RESOLUTION NO. 90-84

**A RESOLUTION OF THE CITY COUNCIL
OF THE CITY OF PASO ROBLES
ADOPTING REVISED STORM DRAINAGE
DETENTION BASIN DESIGN STANDARDS**

CITY OF PASO ROBLES
ENGINEERING DEPT.
LANDSCAPED DRAINAGE BASIN
 STANDARD DRAWING NO. **E-8**

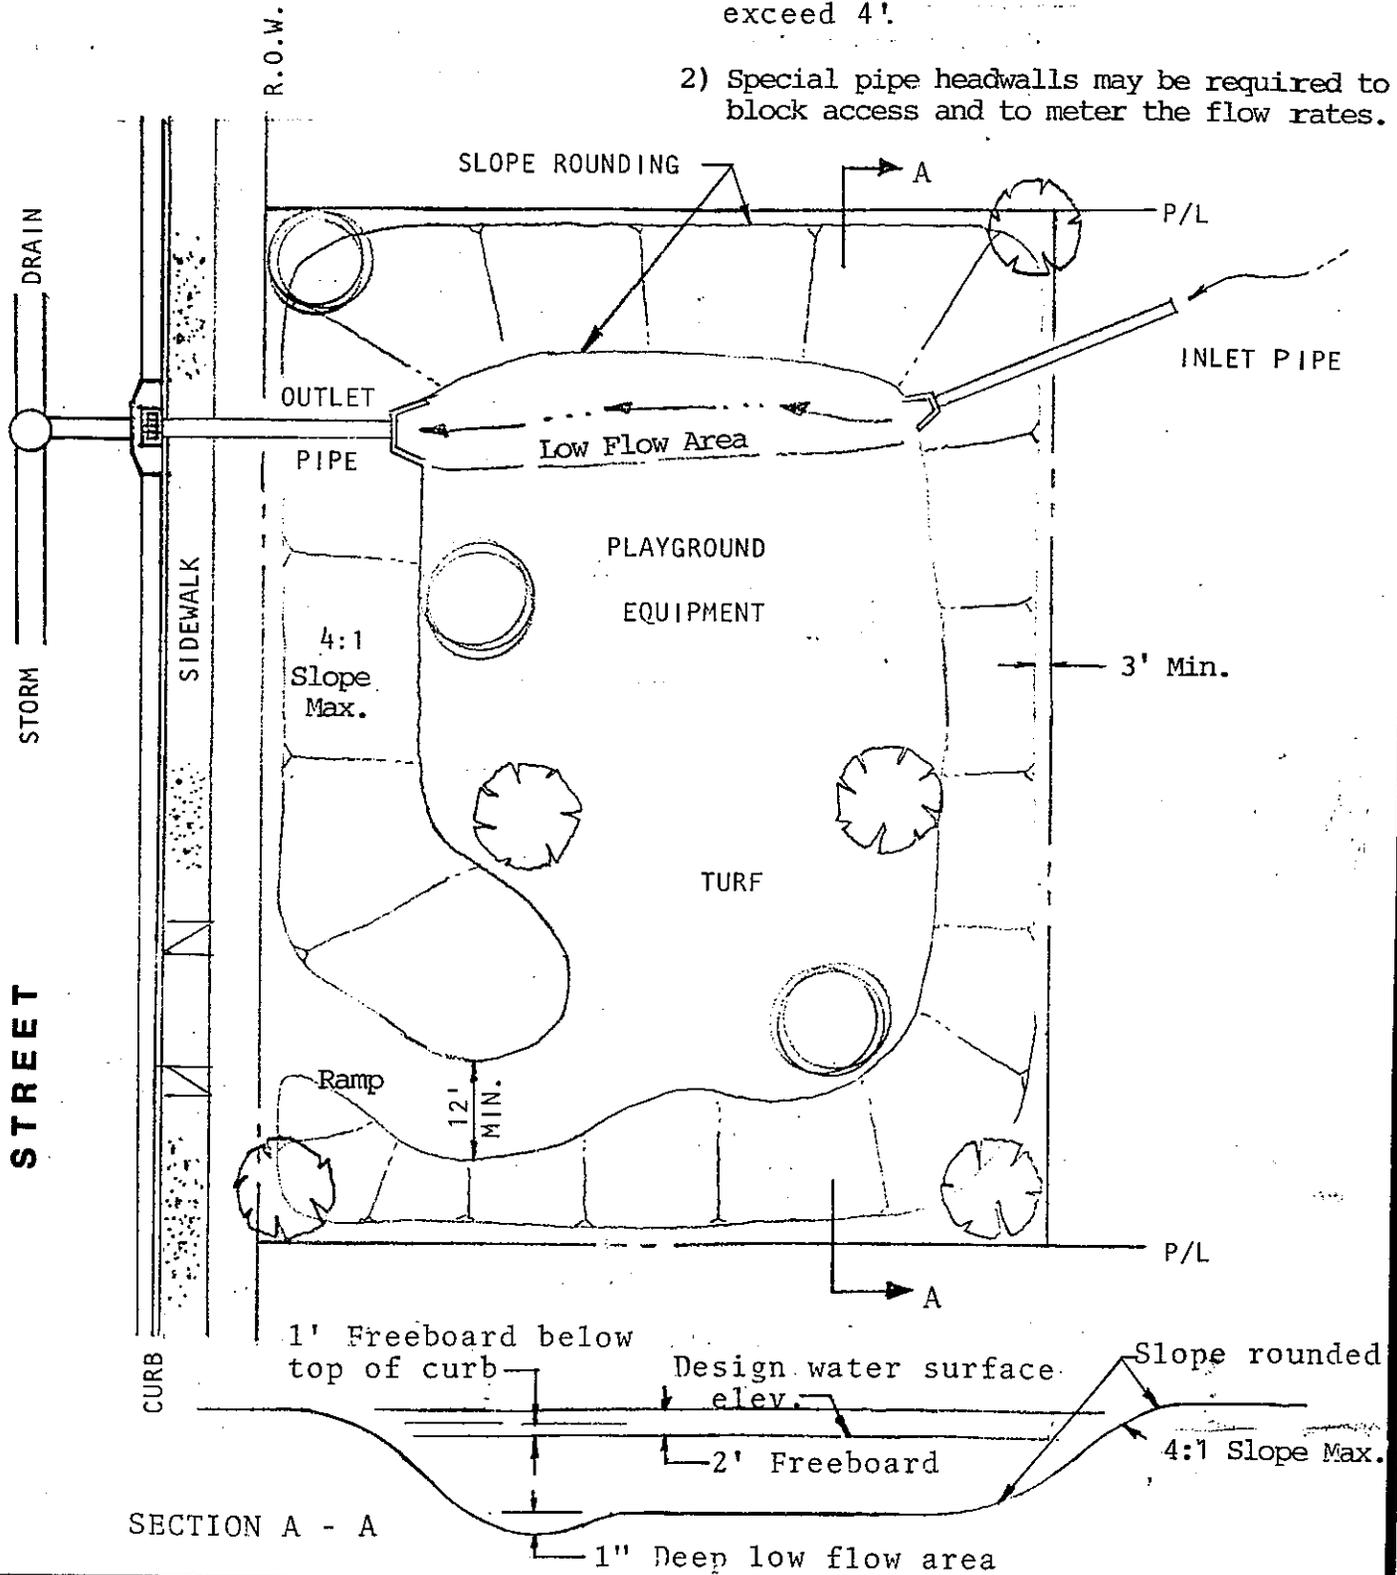
WHEREAS, the revisions include the requirements for park use of the basin by means of contoured grading and landscaping, and allows an increase in the maximum water depth from two feet to four feet. The previous provisions for a deep fenced unlandscaped basin have been eliminated.

c. Landscaped Basins - The typical requirements for a drainage basin shall include a maximum of 4:1 sideslopes with contoured slope rounding for an aesthetic appearance, and a maximum ponded depth of four feet.

Ramps shall be provided for equipment and pedestrian access, and the basin floor shall have a low flow area to convey nuisance drainage flows.

The basin shall be designed as a multi-purpose recreational facility and landscaped accordingly.

Note: 1) Maximum ponded depth shall not exceed 4'.

2) Special pipe headwalls may be required to block access and to meter the flow rates.
